Santa Fe County Development Review Committee
County Commission Chambers
County Administration Building
Regular Meeting

February 21, 2013 at 4:00 PM

FILE REF.: CDRC CASE # Z/S 08-5440- Tierra Bello Subdivision

FILE REF.: CDRC CASE # Z/S 12-5450 Cielo Colorado Subdivision

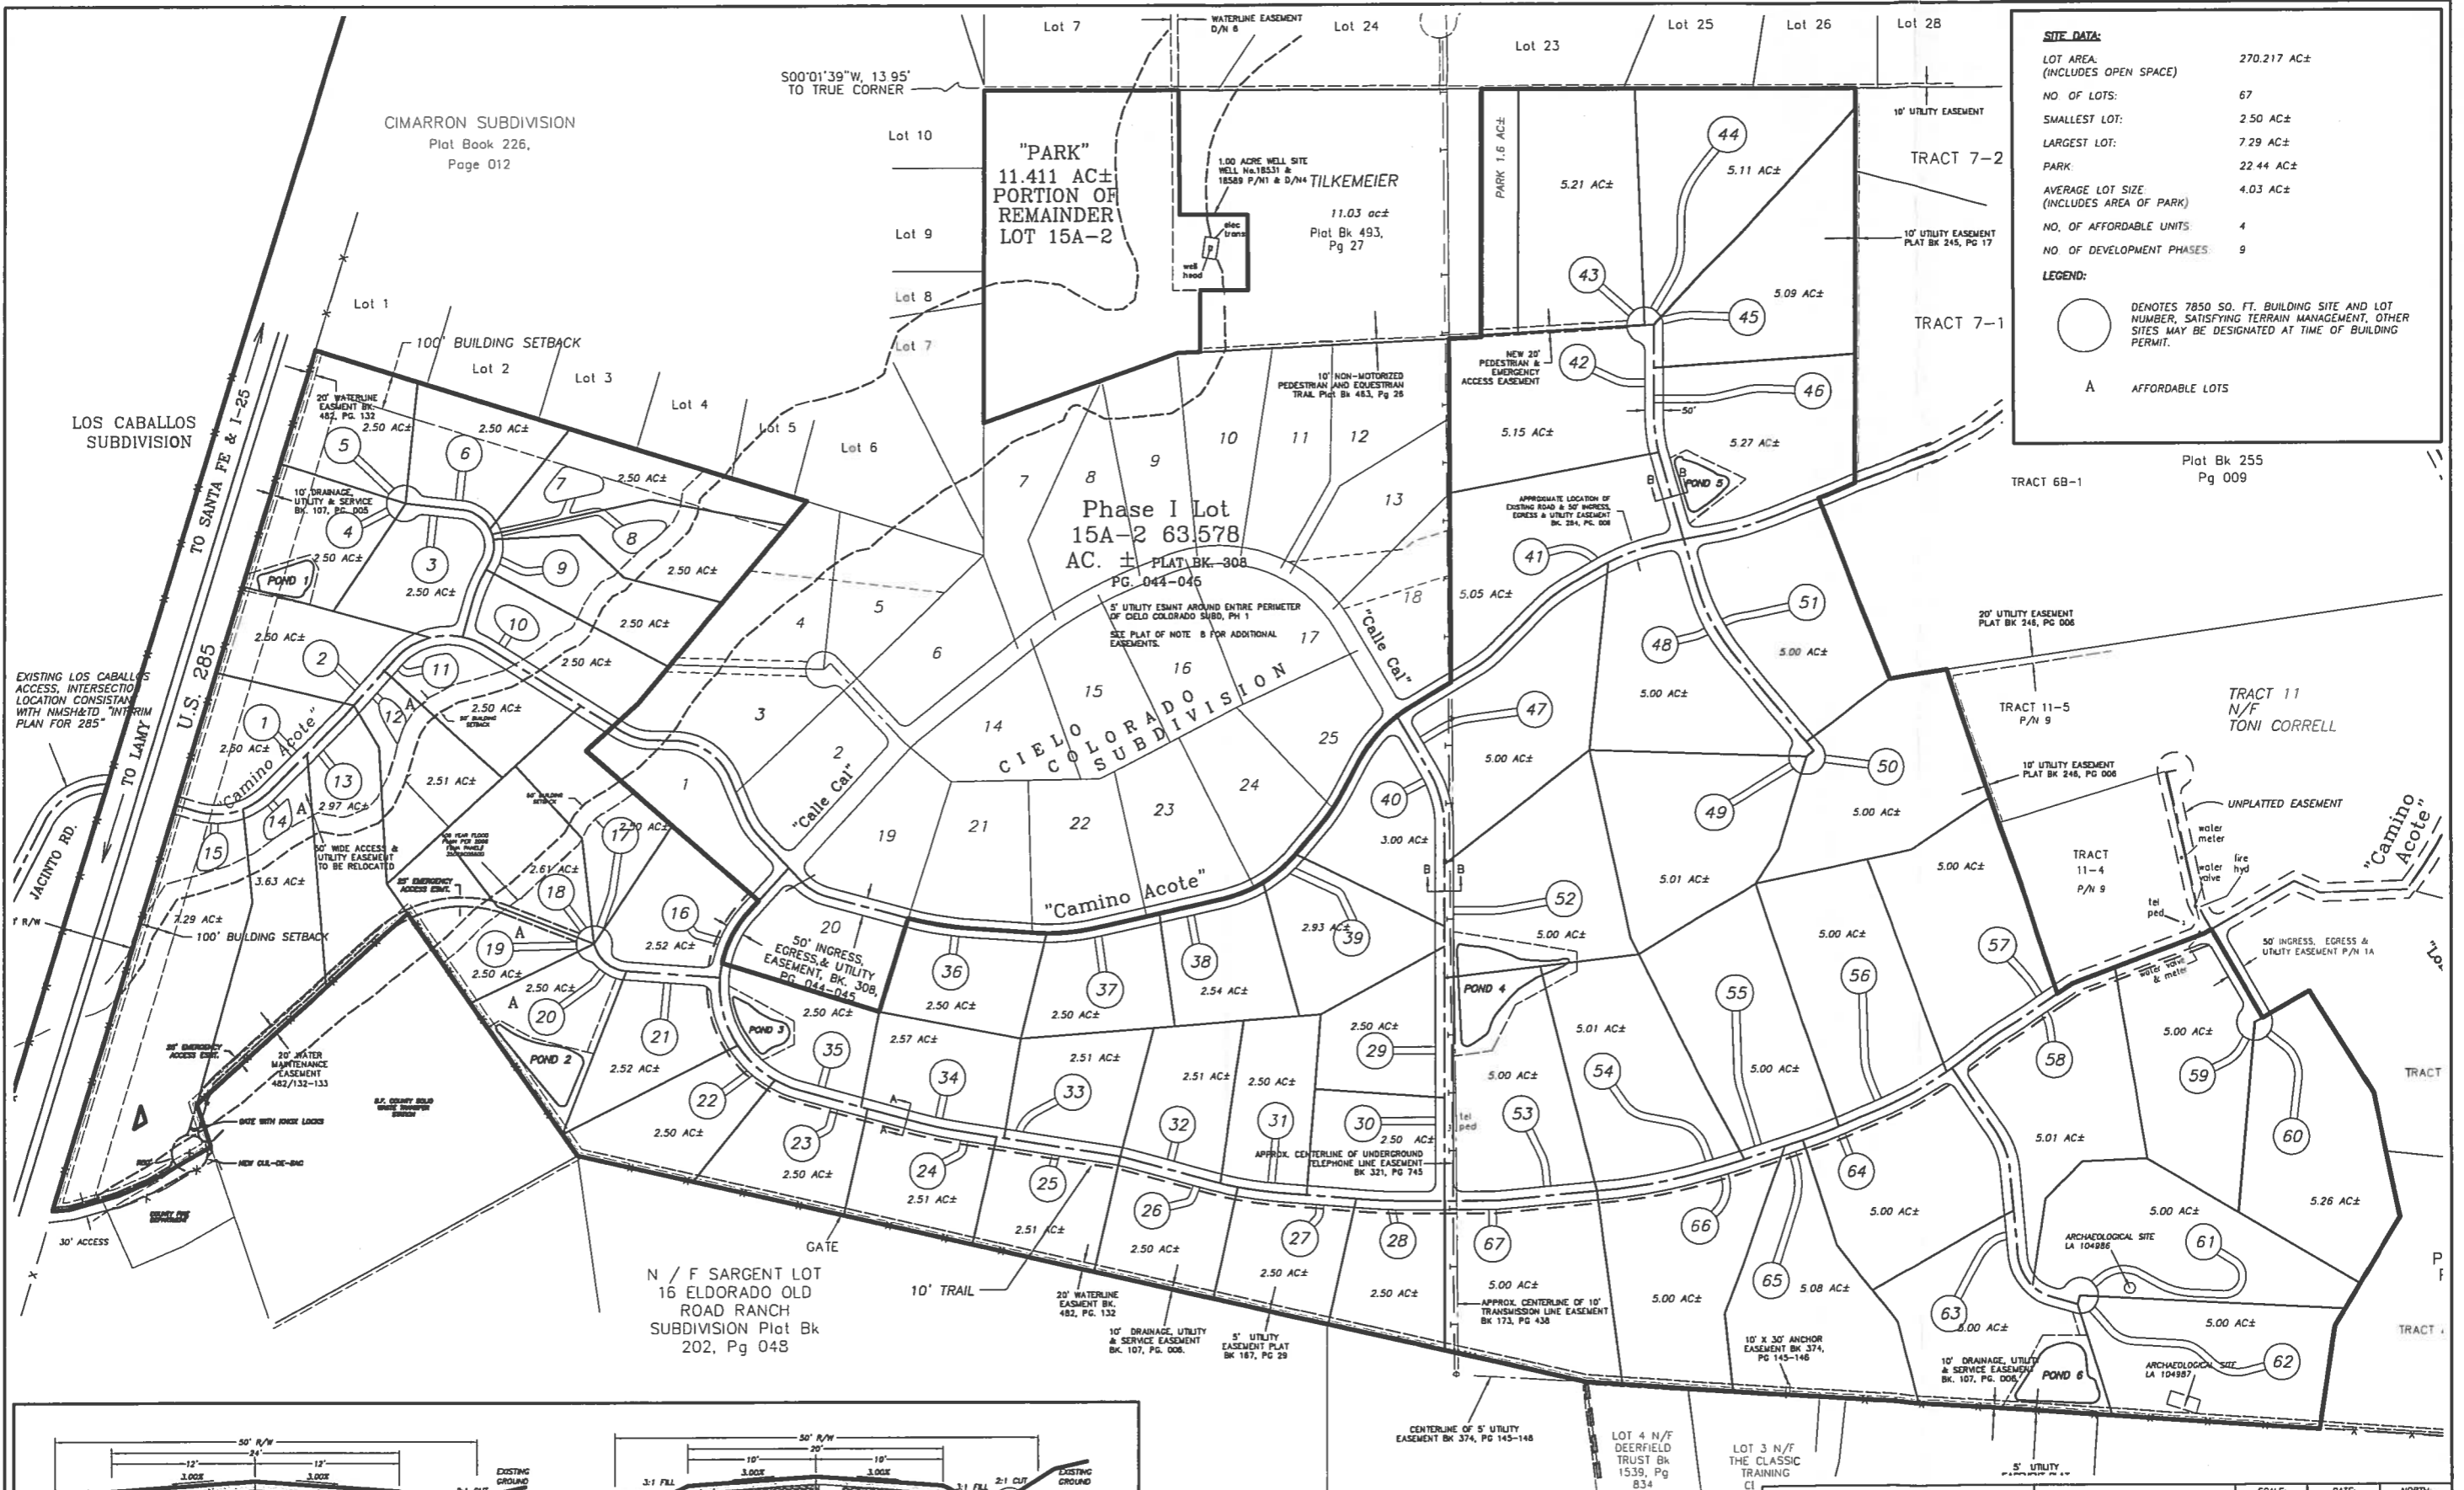
A resident in the Cimarron Subdivision adjacent to the northwest boundary of the master plan is concerned about the dwellings in close proximity to his property and the loss of view.

The location of buildings along the northwest boundary has been moved back from 50 feet to 100 feet. The covenants limit building heights to 15 feet measured from the high point of the lot. The developer will abide by the covenants restricting the height of the buildings.
